BAGHDAD MUNICIPAL
SOLID WASTE LANDFILL

SIGIR PA-06-067
OCTOBER 19, 2006

SUBJECT: Report on Project Assessment of the Baghdad Municipal Solid Waste Landfill,
Baghdad, Iraq (Report Number SIGIR-PA-06-067)

Baghdad Municipal Solid Waste Landfill Synopsis

Figure 3. Cross section of the berm slope

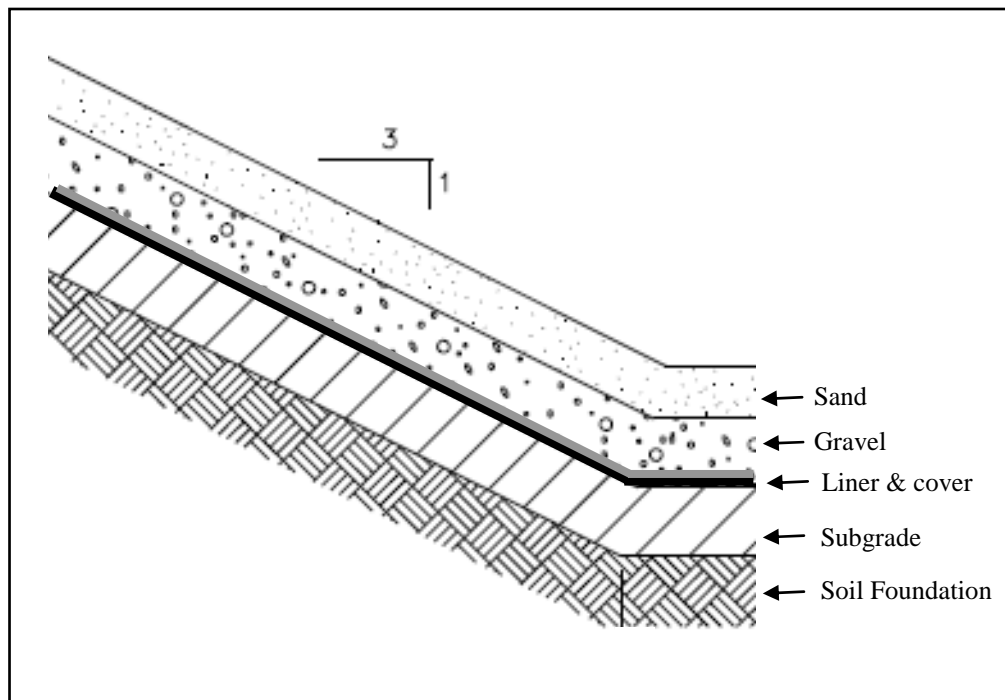
We observed the berm in place along the perimeter of the MSW landfill. The design required the liner system to extend up the 3 horizontal to 1 vertical side slope of the berm and terminate in an anchor trench along the top of the perimeter berm. In the unfinished areas of the landfill, the liner along the inside of the berm, as shown in Site Photo 6, will require remedial work to ensure it is placed and anchored properly.

Site Photo 11. Landfill site electrical generator

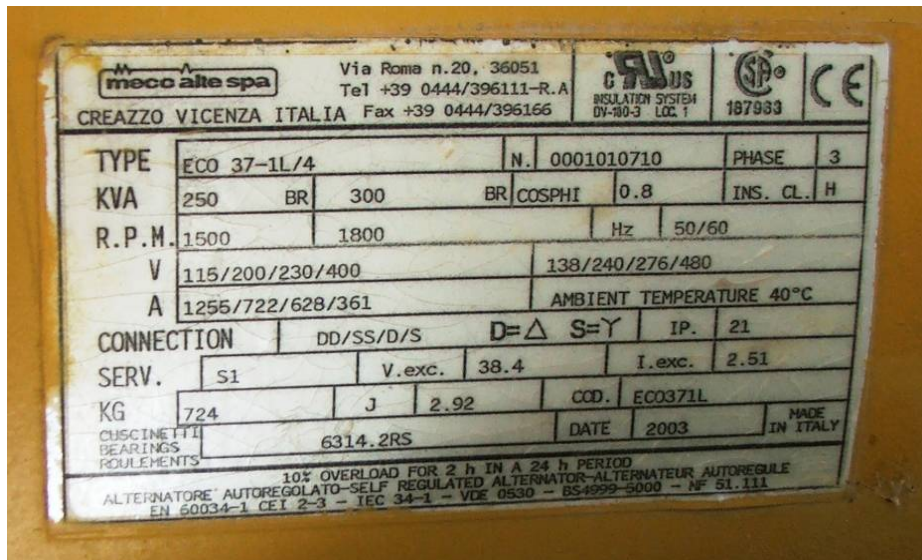
The generator on site is shown in Site Photo 11. The factory plate attached to the generator shows an Italian made “Mecc Alte Spa ECO 37-1L/4250 KVA” generator. However, the generator skid indicates an “AKSA” model generator. AKSA generators are manufactured in Turkey. Further, the factory plate (Site Photo 12) has yellow paint on its surface indicating the generator was painted after the factory plate was attached.

In addition, we observed several examples of questionable workmanship associated with the installation of the generator.

- The exhaust stack, shown in Site Photo 11, was not properly supported. Also, it appears vibration of the generator could damage the roof and/or generator because the stack location being so close to the metal frame and the roof skin.
- The feeder cable shown in Site Photo 13 was not properly installed in conduit. The connection to the generator control panel was made with exposed wire, not enclosed in conduit. Further, part of the feeder cable was lying exposed on the ground surface. The cable was not in conduit as required by the design nor buried to a proper depth.
- The generator skid was not anchored to the concrete pad.

Site Photo 13. Exposed cable and wire

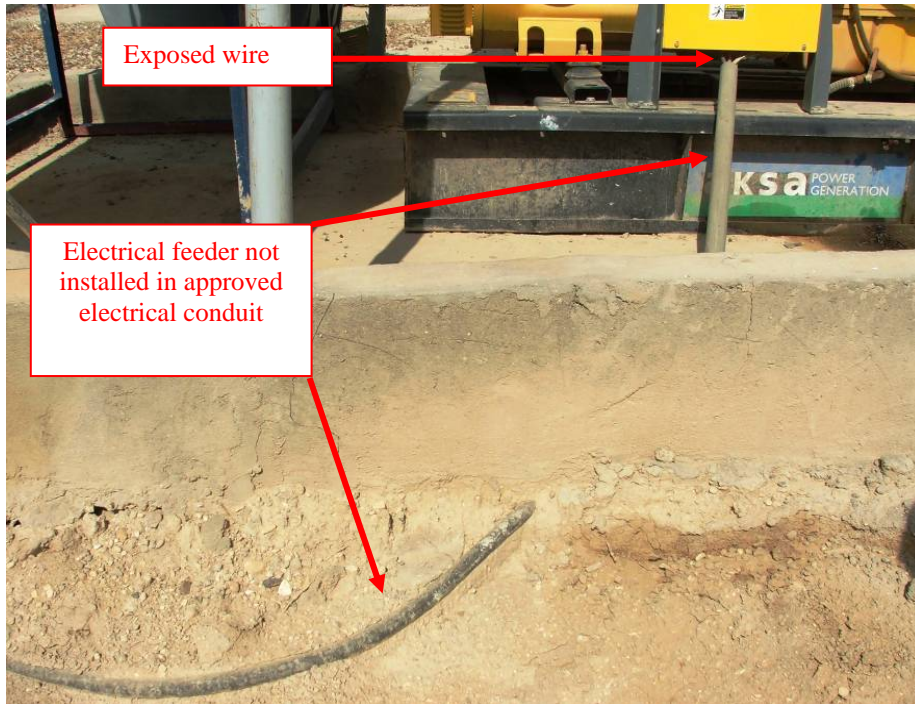
We also observed poor wiring installation on one of the dedicated electrical circuits in the maintenance bays (Site Photo 14). It appears there is a non-acceptable splice on the line side of the circuit breaker, as evidenced with the taped wiring. We also observed exposed wiring at other locations around the exterior of the building. In addition, the circuit breaker shown below should be in an enclosed circuit breaker panel.
